# Access Compliance Report

## Public Rights-of-Way

### (Curb Ramps)

Intersection ID: 29760	Main Street: CREEK_POINTE_DR	Cross Street: FAWN_HILL_RD	Location: NE
ADA ID: D3DF897F43F4	Ramp Type: Perp	Initial Pass/Fail: Fail	Overall Compliance: No
Severity Score: 10			
Codes/Mitigation Info/Possible Solution		Field Measurements/Component Compliance

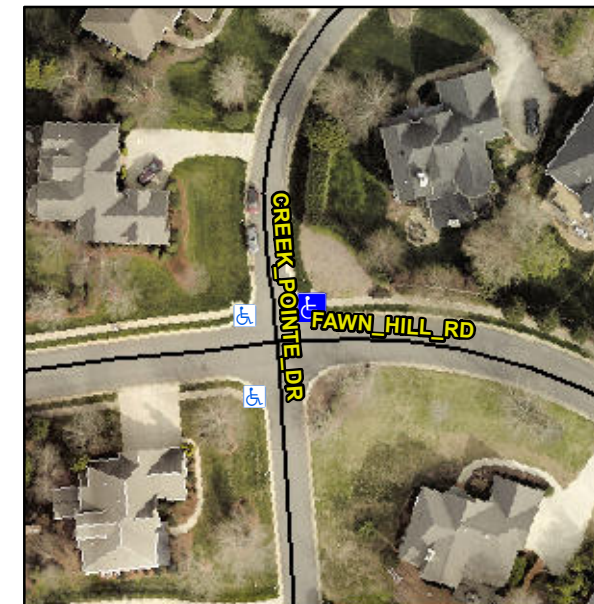
**Not Found, R304.5.1, R304.5.3**

Compliance	Description	Data	Compliance	Description	Data
N/A	Ramp Length (in)	46.5	Yes	Ramp Slope (%)	7.9
No	Ramp Width (in)	43.0	No	Ramp XSlope (%)	2.3
N/A	Flare Type LT	N/A	N/A	Flare Type RT	N/A
N/A	Flare Slope LT (%)	N/A	N/A	Flare Slope RT (%)	N/A
N/A	Flare Traversable LT?	N/A	N/A	Flare Traversable RT?	N/A
N/A	Landing Length (in)	N/A	N/A	DWS Provided?	N/A
N/A	Landing Width (in)	N/A	N/A	DWS Contrast?	N/A
N/A	Landing Slope (%)	N/A	N/A	DWS Length (in)	N/A
N/A	Landing X Slope (%)	N/A	N/A	DWS Full Width?	N/A
N/A	Landing Curb? (Y/N)	N/A	N/A	DWS Offset (in)	N/A
N/A	Shared Landing?	N/A			
N/A	Gutter Ponding?	N/A	N/A	Gutter Slope (%)	N/A
N/A	Gutter Lip Ht (in)	N/A	N/A	Gutter X Slope (%)	N/A
N/A	Painted X Walk1?	No	N/A	Painted X Walk2?	N/A
	X Walk 1 Direction	To W		X Walk 2 Direction	N/A
N/A	X Walk 1 Width (in)	N/A	N/A	X Walk 2 Width (in)	N/A
	X Walk 1 Slope (%)	2.7		X Walk 2 Slope (%)	N/A
	X Walk 1 X Slope (%)	1.3		X Walk 2 X Slope (%)	N/A

**Remove & Replace Entire Ramp.**
